East Anglia ONE North and East Anglia TWO Offshore Windfarms

Applicants' Comments on SASES' Deadline 7 Submissions

Applicant: East Anglia TWO and East Anglia ONE North Limited
Document Reference: ExA.AS-22.D8.V1
SPR Reference: EA1N_EA2-DWF-ENV-REP-IBR-001017

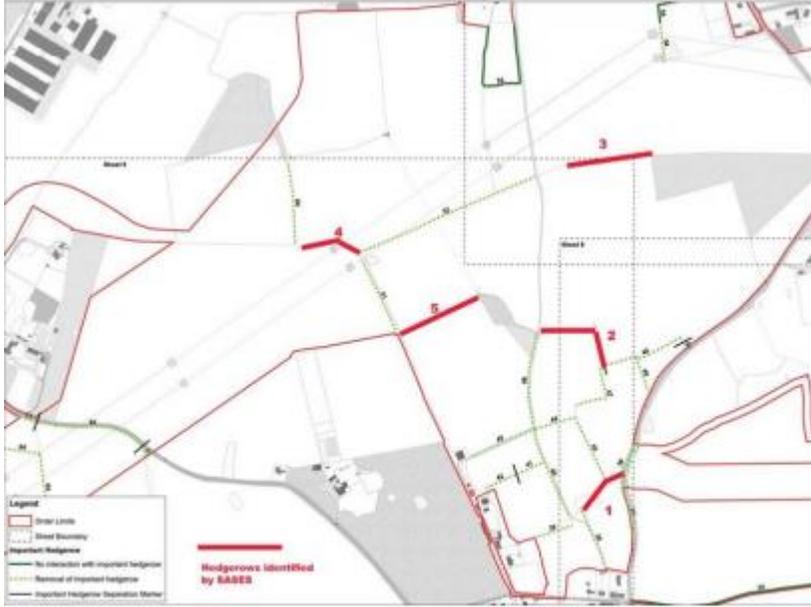
ID	SASES' Comment	Applicants' Comments
	<p>agricultural area. It should be noted that there is an unlimited fine if Protected Hedgerows are removed without consent.</p>	<p>modifies Regulation 6 of the Hedgerows Regulations so that removal of hedgerows to which the Regulations apply is permitted for carrying out development which has been authorised by a DCO. This aligns with the position where development is carried out in accordance with a planning permission.</p> <p>The removal of hedgerows will be controlled through the approval of the Ecological Management Plan in accordance with Requirement 21 of the (document updated at Deadline 8, document reference 3.1).</p>
6	<p>In respect of the substation site shown on Sheet 7 of the Important Hedgerows Plans, there are a number of existing hedgerows, which have not been scheduled for removal but almost certainly will be removed as they fall within the proposed built environment. Map 1 shows these additional hedgerows with referencing photographs which follow.</p>	<p>The Applicants identified the important hedgerows within the Important Hedgerows and Tree Preservation Order Plan (REP3-010) as per the criteria set out in the Hedgerows Regulations 1997. The Applicants consider that identifying important hedgerows to be removed or be crossed by the onshore cable route using a reduced working width is appropriate and proportionate. The removal of other hedgerows will be controlled through the approval of the Ecological Management Plan in accordance with Requirement 21 of the DCO.</p> <p>However, the Applicants would also note that the majority of linear features that SASES identifies as hedgerows were not recorded as such, or were recorded as defunct during the extended Phase 1 habitat surveys undertaken to support the Applications.</p>

ID	SASES' Comment	Applicants' Comments
	 <p><i>Map 1: Hedgerows on Substation Site. Thick red lines show existing from EA1N & EA2 Important Hedgerow Plans.</i></p>	
7	<p>It is also not clear what the intention is with regard to the mature hedgerow on the western boundary of the substation site with Footpath 17. The red line boundary appears to enclose the hedgerow and the hedgerow is therefore at risk.</p>	<p>SASES will have to provide further clarity as it is the Applicants understanding that Footpath 17 is not routed to the west of the onshore substation locations.</p>
8	<p>The Applicants say that there are 67 Important Hedgerows which require removal, however this number of affected hedgerows is significantly understated as no Protected Hedgerows have been identified on the plans. An Important Hedgerow has different</p>	<p>The Applicants consider that identifying important hedgerows to be removed or be crossed by the onshore cable route using a reduced working width is appropriate and proportionate. The removal of other hedgerows will</p>

ID	SASES' Comment	Applicants' Comments
	<p>criteria, as follows: it is at least 30 years old; marks all or part of a parish boundary that existed before 1850; contains an archaeological feature; is in or next to an HER: marks the boundary of an estate that existed before 1600; is part of a field system that existed before 1845; contains protected or endangered species; includes woody species specified in Schedule 1 of the Hedgerow Regulations</p>	<p>be controlled through the approval of the Ecological Management Plan in accordance with Requirement 21 of the DCO.</p> <p>However, the Applicants would point to the Extended Phase 1 Habitat Survey Results (APP-277). Of all the hedgerows recorded within the Order limits, there are very few (less than 10) that are not included on the Important Hedgerows and Tree Preservation Order Plan (REP3-010).</p>
9	<p>Selecting just Important Hedgerows has resulted in Protected Hedgerows being omitted from the DCO. This area of East Suffolk is rich in hedgerows and there will be wholesale destruction along the full length of the cable route and substation site resulting in a dramatic change in character of the area and loss of habitat for wildlife.</p>	<p>The Applicants consider that identifying important hedgerows to be removed or be crossed by the onshore cable route using a reduced working width is appropriate and proportionate. The removal of other hedgerows will be controlled through the approval of the Ecological Management Plan in accordance with Requirement 21 of the DCO.</p>
